Berkeley Water Transportation Pier Ferry Project

Final Environmental Impact Report

City of Berkeley
Parks, Recreation, & Waterfront Department
2180 Milvia Street, 3rd Floor
Berkeley, California 94704
Contact: Liza McNulty, PE

Rincon Consultants
66 Franklin Street, Suite 300
Oakland, California 94607

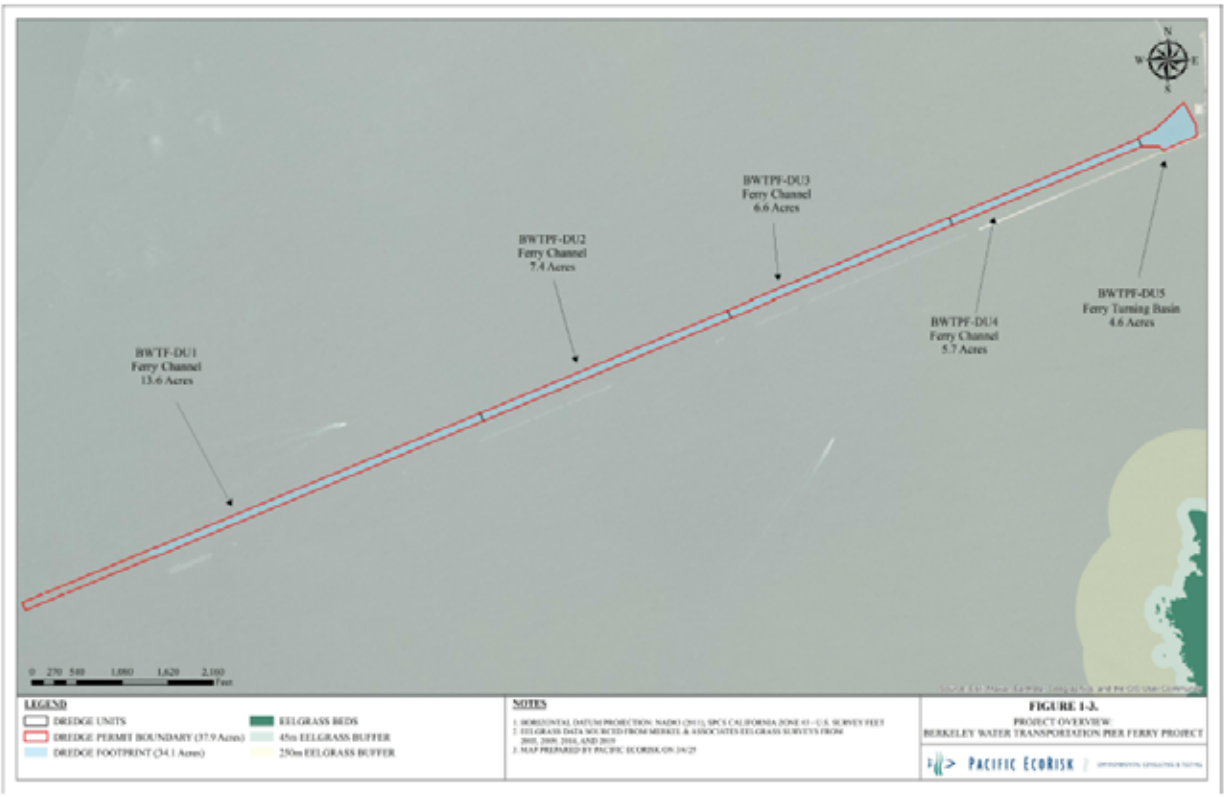
The area intended to be dredged as envisioned under the current Project is orders of magnitude larger, indicated in the images below. There is no overlap in the Berkeley Marina dredging event except for a small section inshore. There is also no footprint overlap with any other dredging project past or present. Section 15125 of CEQA also says (3) An existing conditions baseline **shall not include hypothetical conditions**, such as those that might be allowed, but have never actually occurred, under existing permits or plans, as the baseline. In this case, any broader plans for dredging cannot be used as a baseline (as basis to claim maintenance dredging), even if it was permitted.

The dredging location within the project site, including the proposed ferry turning basin, is identified in Figure 2.2, page 2-3 of the Draft EIR. No Draft EIR changes are necessary in response to this comment.

DEIR cover of the proposed pier and Figure 2-4 water rendering show no ferry vessel.

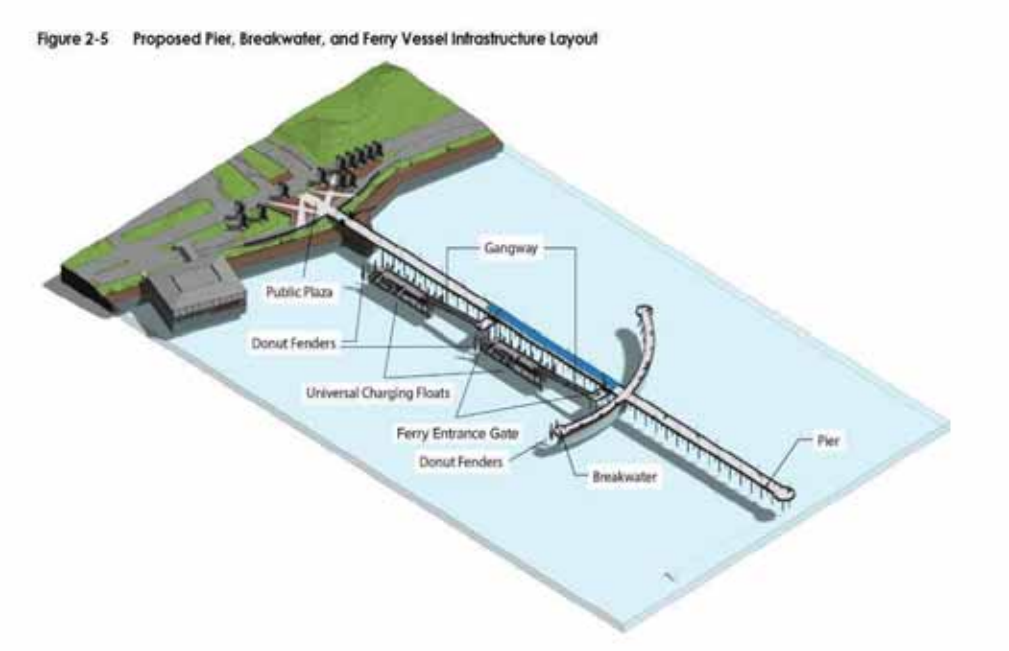
Second, the central visual element of the project — the ferry vessel itself — is absent from the DEIR's renderings and infrastructure figures. The project proposes ferry operations with approximately 28 weekday and 26 weekend crossings at a new 1,080-foot pier on the Berkeley waterfront. The DEIR cover rendering depicts the proposed pier with two pedestrians and a sailboat in the middle distance. No ferry vessel is shown. This is the image members of the public encounter first when reviewing the project, and it **portrays a misleading and largely inaccurate representation of the visual change** the project would introduce.

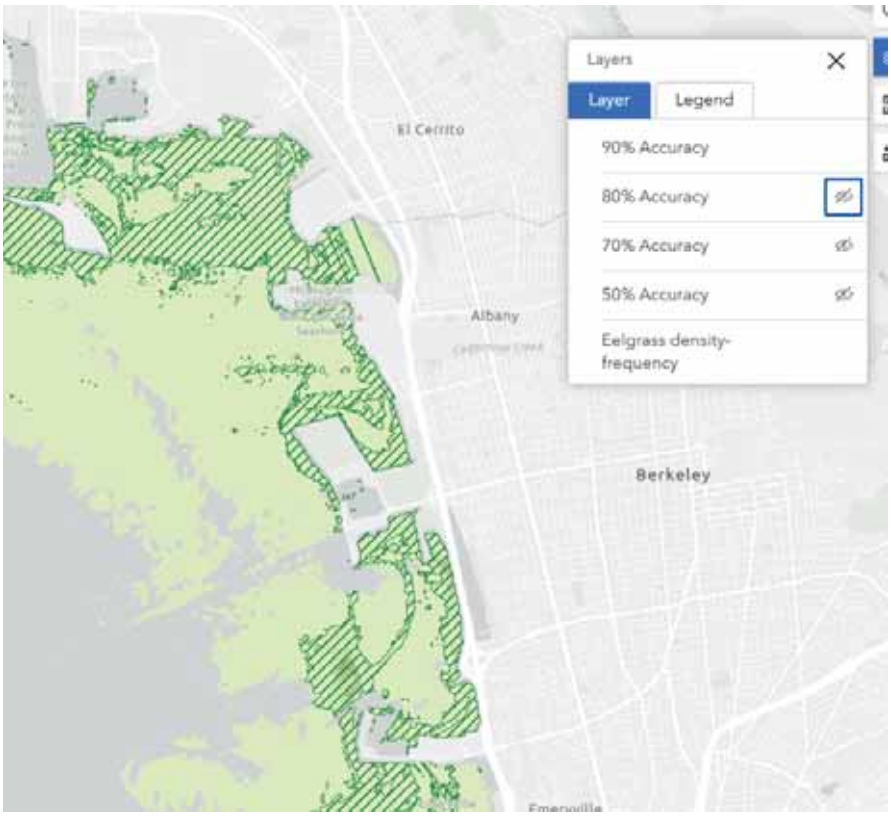
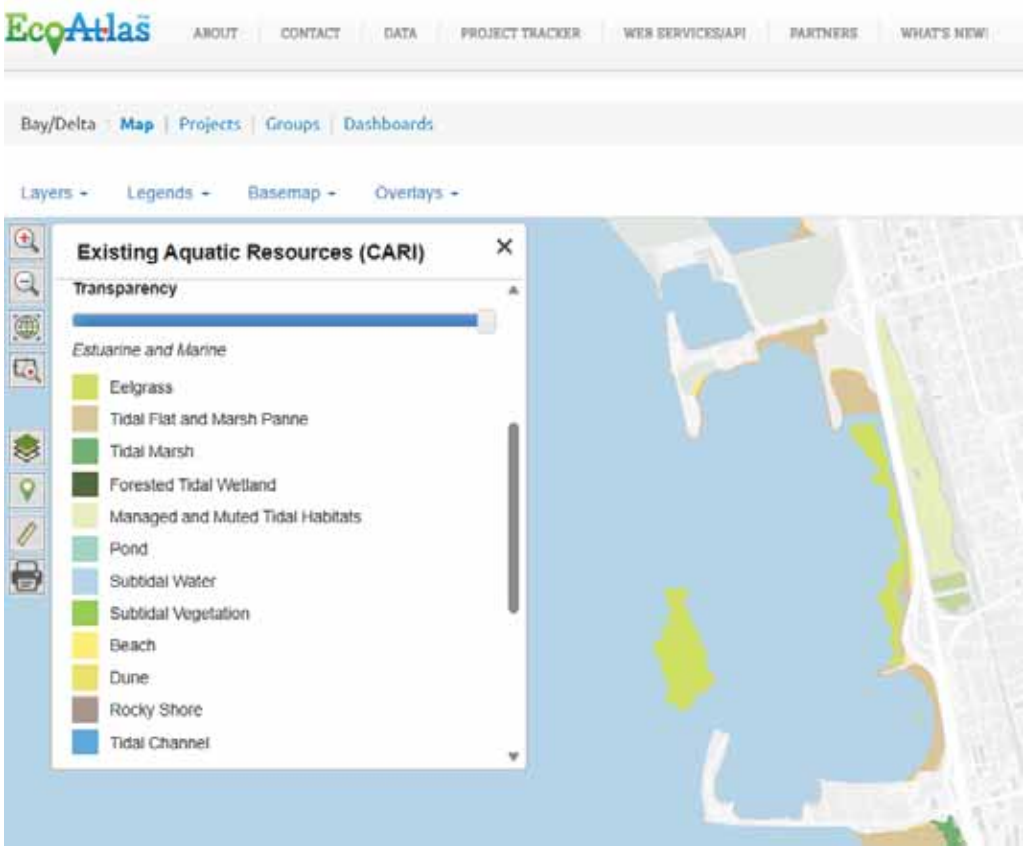
It also appears that the existing pier itself, both the pedestrian portion (out to 3000' and closed in 2015) and the "ruins," beyond the "gap," provides eelgrass shelter from wave action, as seen by the greater concentration of eelgrass indicators just north of and parallel along the pier.

As stated in the Draft EIR, Section 3.3.2 (pages 3.3-11 through 3.3-13) and shown on Figure 3.3-2 on page 3.3-9, there is no eelgrass habitat within the project site, and no project impacts related to or loss of eelgrass habitat would occur. In addition, see Response to Comment O4-7 for further discussion regarding the absence of eelgrass at the project site. Finally, carbon sequestration is not a topic required for analysis pursuant to CEQA and CEQA Guidelines. No changes to the Draft EIR are necessary in response to this comment.

Figure 2.0
Marina Master Plan

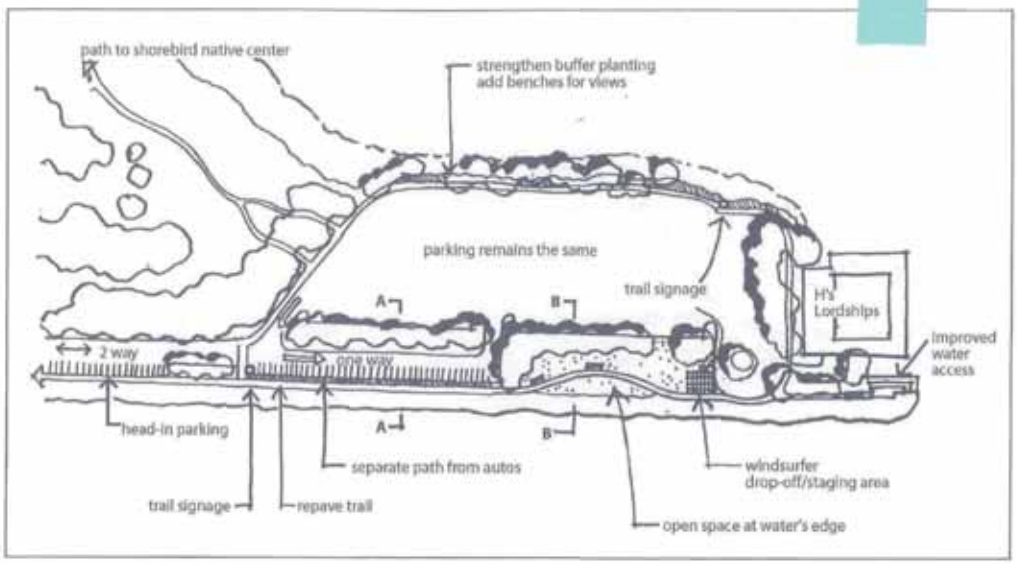
In both adopted policies and in land use designations, there are fundamental conflicts between the Berkeley Marina Master Plan (BMMP) and the project contemplated in the EIR. Most of these can be seen by reviewing the adopted map, Figure 2.0. Those conflicts include:

- The only ferry site considered in the plan is located within the marina, and the plan adopts policies to make that site seismically safe.
- The site now proposed for a ferry terminal and ferry parking is designated for other recreational uses, including enhanced windsurfing access. An illustration of that concept is provided in Figure 12, that shows head in parking for public viewing, improvements to the windsurfing launch and staging area, and open space at the water's edge. The proposed project conflicts with this plan by eliminating much of the open space on the peninsula, not increasing it, eliminating the staging area for windsurfing, and eliminating most of the parking places that are currently used for fishing access and viewing the Bay. The EIR does not discuss any of these conflicts. The project entails removal of much of the green area and landscaping that now exists, including 40 trees (or perhaps 39; both numbers are provided) and makes no quantitative assessment of the impact on open space.

Regarding the statement that "the only ferry site considered in the plan is located within the marina, and the plan adopts policies to make that site seismically safe", the City has reviewed the Berkeley Marina Master Plan, including Figure 2.0, which is referenced in this comment, and has found no mention of a new ferry site. The Berkeley Marina Master Plan does reference an existing "ferry pier" when discussing compliance with seismic regulations, under Principle 3. The first policy under Principle 3 is to "update the ferry pier to comply with seismic regulations." Page 3.9-32 of the Draft EIR analyses consistency with this policy, and finds that the project would be consistent with this policy.

to this comment and to provide additional clarification about the project, the EIR has been revised to include a discussion of Figure 2.0: Marina Master Plan. While the comment addresses Figure 12.0, it should be noted that Figure 12.0 is a concept plan. For that reason, the EIR considers Figure 2.0. The EIR has also been revised to include a discussion of a relevant policy in Principle 4, Item C.

Kerrily's parking idea

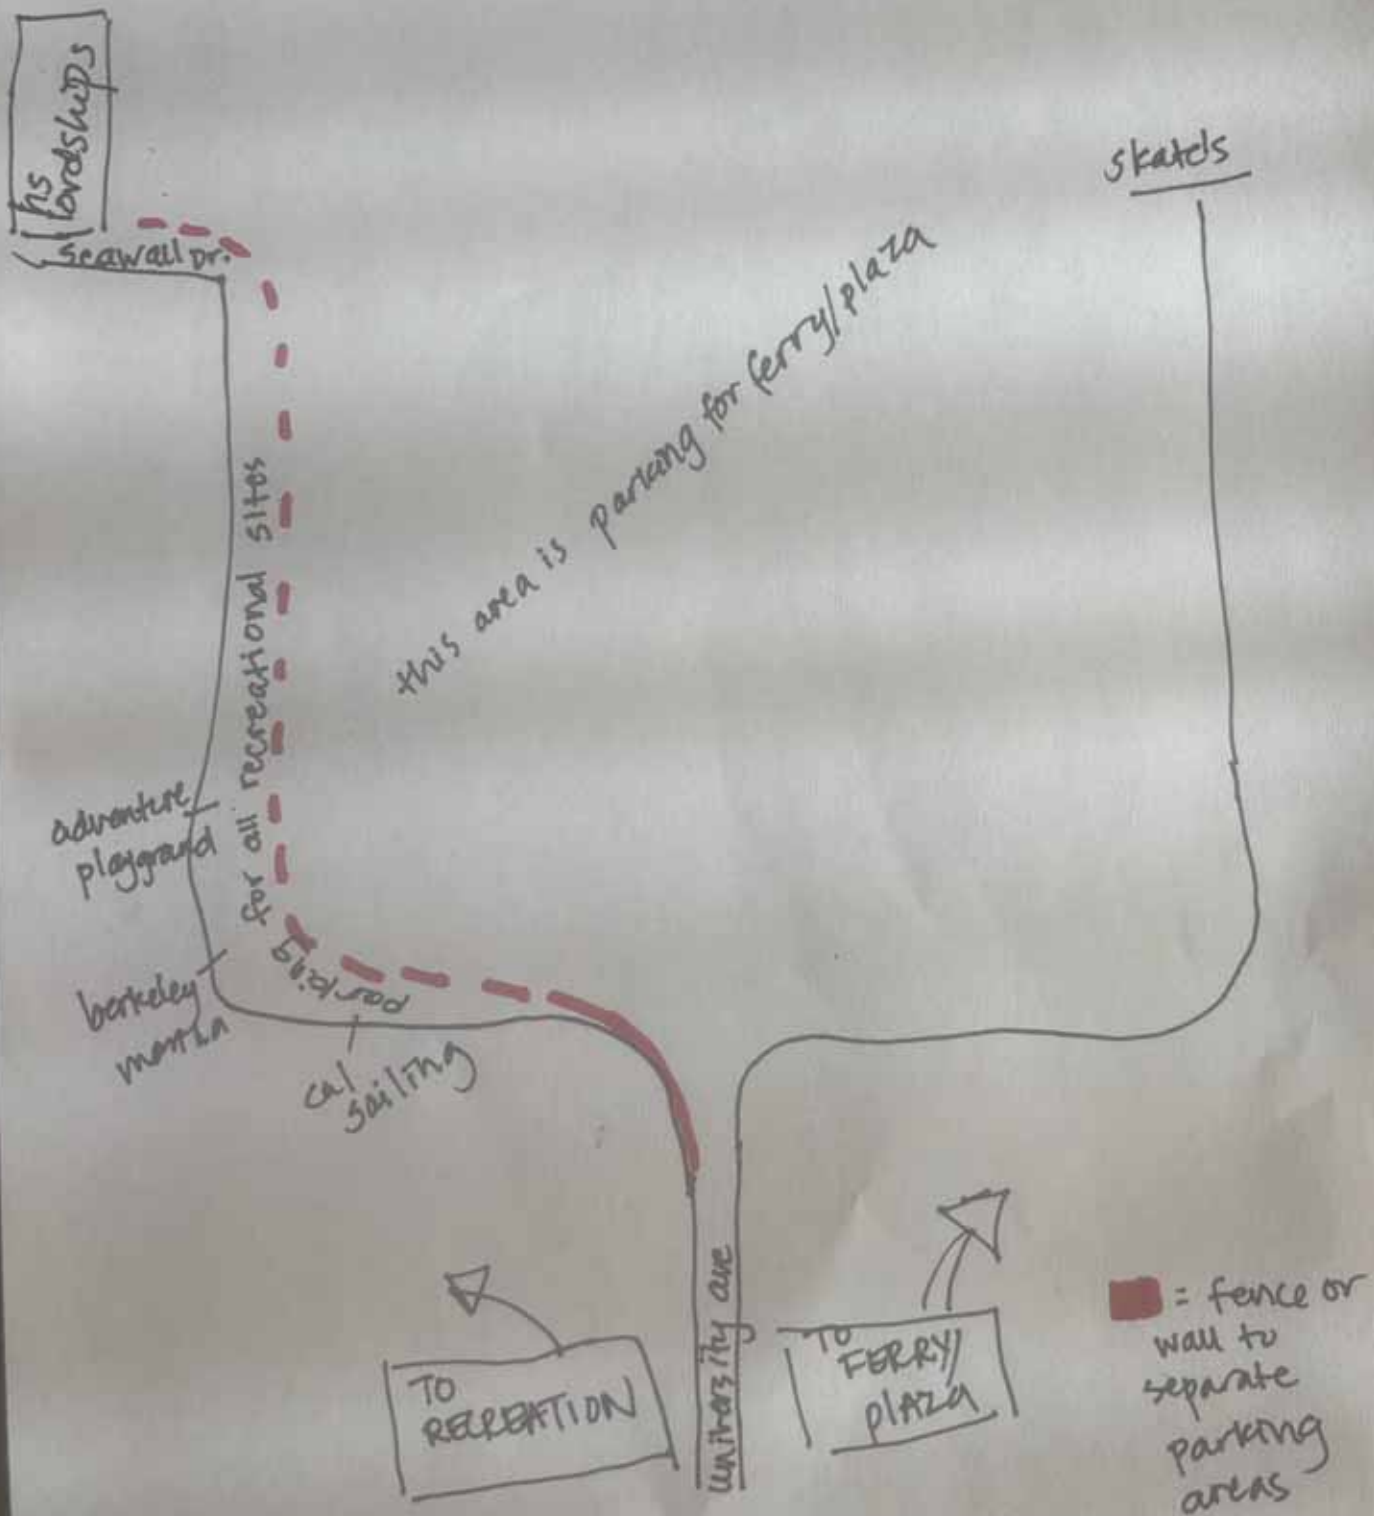
I do have an idea for parking that I think could protect access to these sites. My idea is actually quite simple. At the entrance to the Berkeley marina, have a road to the left which includes present day Cal Adventures, Adventure Playground, Berkeley marina, HsLordships. To the right, another road leading to Berkeley Ferry and Pier. SEPARATE the two with a fence or wall, which could be as cheap and ugly or as beautiful and expensive as you want. Keep designated parking along the left side/recreational sites as limited or as extensive as you want, depending on placement of the fence/wall. Recreational users will not compete with ferry users for their spots to which they can carry heavy equipment and swimmers won't have to walk long ways in their cold, wet gear especially in the winter time. Ferry users won't be able to access these limited parking spots without having to climb the wall/fence. You can keep the lion's share of parking spaces for ferry users, as long as there are ample spaces for recreational users. I'm not sure if the description here is as clear for you to visualize as it is in my imagination. I am happy to expound on it if you'd like. In fact, I will follow-up with a hand drawing of this idea in the next few days. P56-3

The way that parking and access to recreation is currently planned does not respect and realistically address the needs of those who use it for this purpose. Please find an alternate way of addressing it. P56-4
